T.I. no.: 2018 - 04 Updated: -	Topic: Improved Best Foam blender
---	--

IMPROVED BEST FOAM BLENDER (SCA P BF)

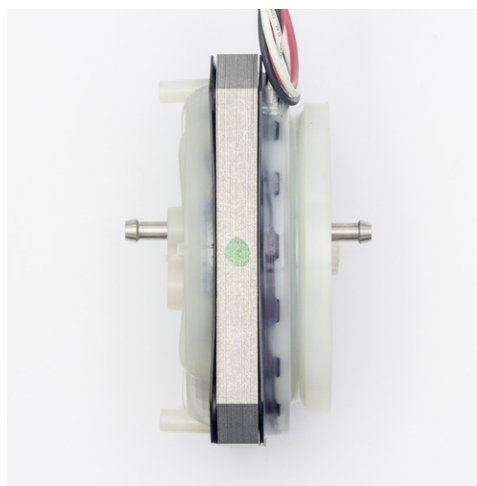
The Best Foam blender has been redone and will be used in all SCA P Best Foam machines starting on 12/2/2018. The orange silicon hose (4/8) 074546 will be replaced by the white transparent silicon hose (3/6) 063123. These measures have improved the milk foam quality.

New Art. no. 33.2928.1200.
